Alabama State Port Authority
Addendum to R&P or Specification Booklet

Project Name Pier C North Rehabilitation, Phase I – Storage Yard

AFE # 9358 **CN #** 2032 **Addendum #** 5

ADDENDUM # 5

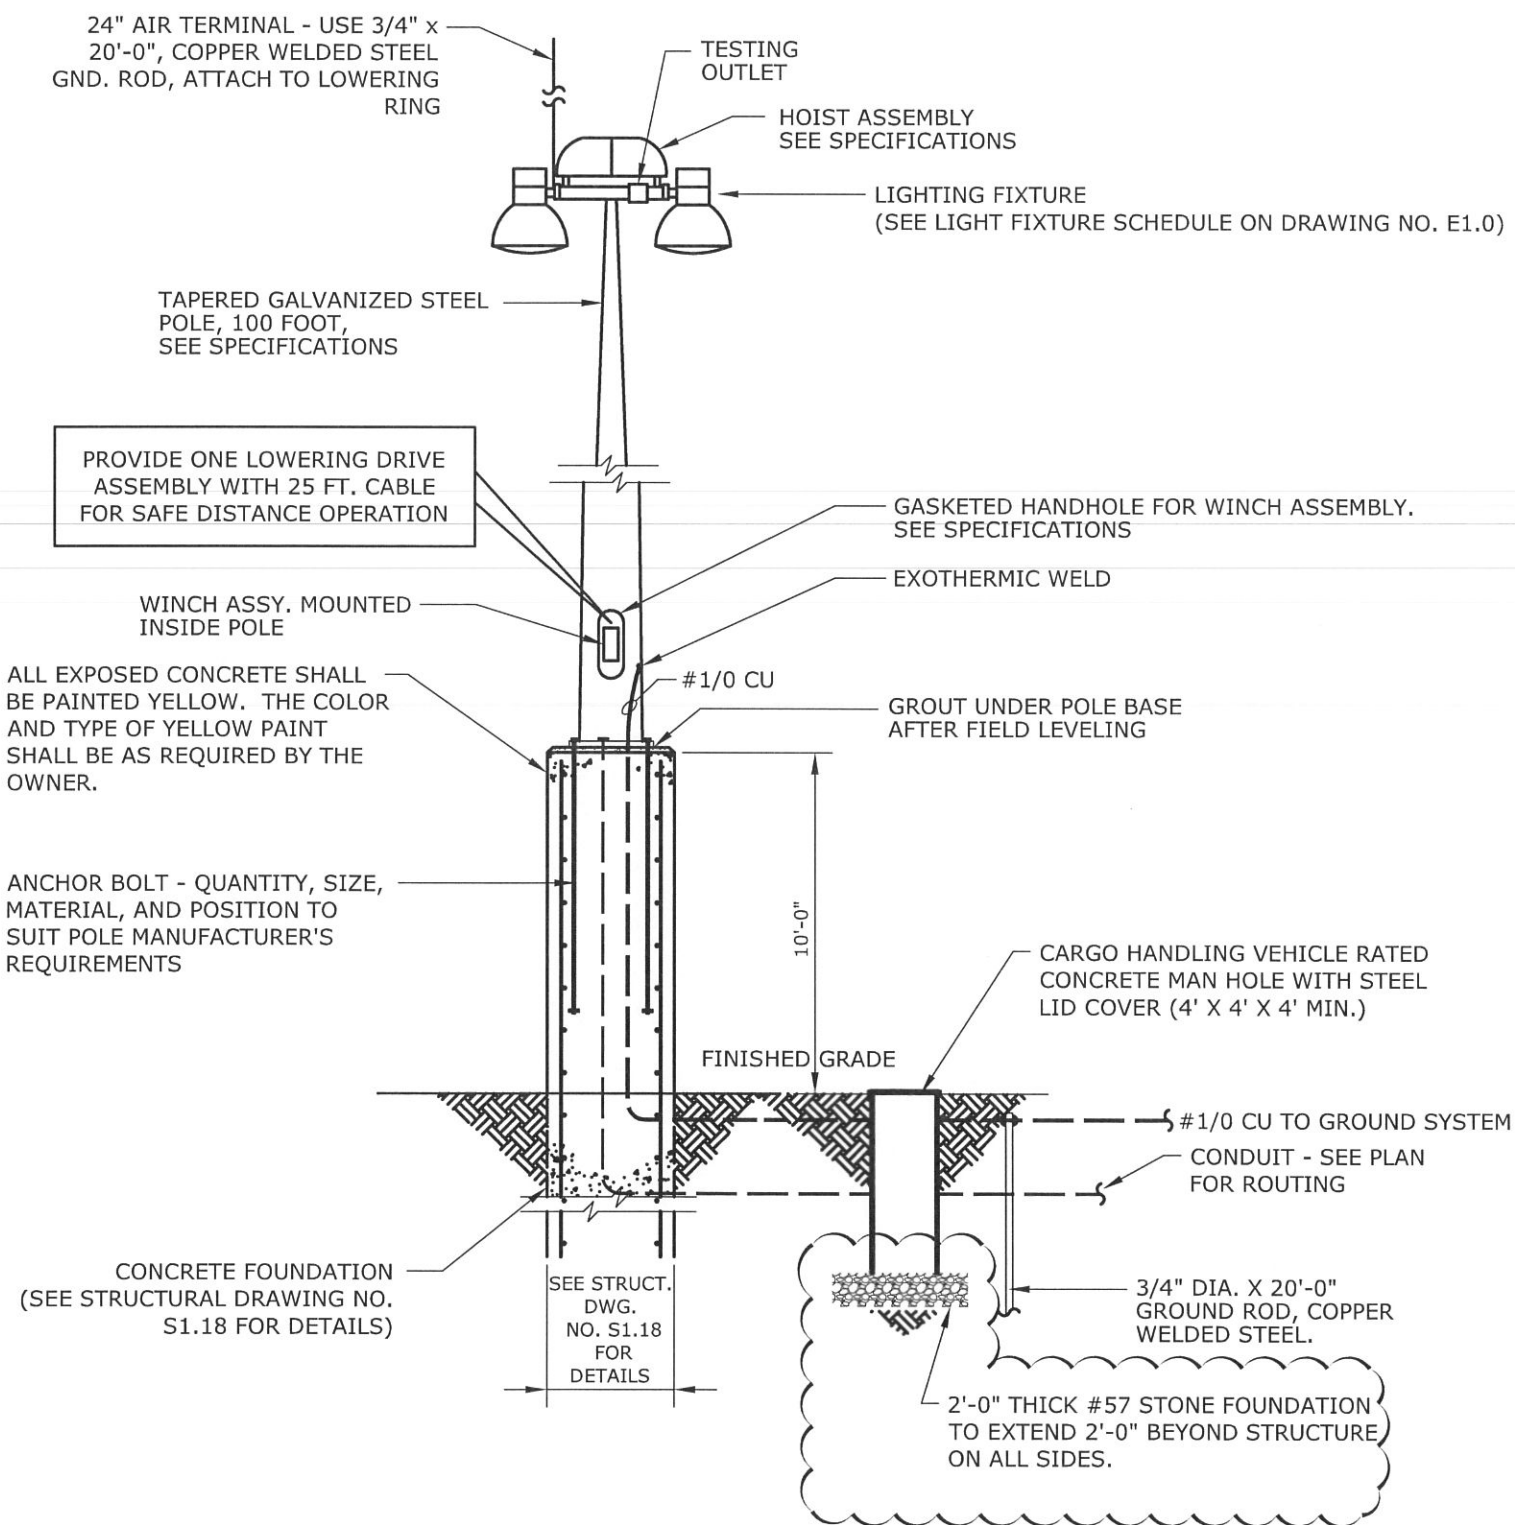
44. Question: Please provide specifications for the Bid Item #36 "Traffic Rated Concrete Man Hole with Steel Lid sized as required". The only information available is the standard detail on sheet E3.1 which calls these six electric pull boxes out as "Cargo Handling, Vehicle Rated Concrete Man Holes with Steel Lid Covers (4'x 4'x 4'min). They are shown with no bottom slab and no dimensions.

Answer: Note 25 on Sheet E1.0 is revised to read as follows:

ALL MANHOLES SHALL BE PRECAST CONCRETE CARGO VEHICLE RATED WITH BOLT DOWN GASKETED STEEL LID. ALL MANHOLE JOINTS SHALL BE GASKETED. THE MANHOLE AND LID SHALL BE CAPABLE OF WITHSTANDING A MINIMUM OF 110,000 POUNDS. PVC AND FIBERGLASS SHALL NOT BE ACCEPTABLE UNLESS OTHERWISE NOTED. SEE DETAILS ON DWG. NO. E2.1, E2.2, AND E3.1 FOR LOCATIONS.

A revised manhole detail is provided by this addendum.
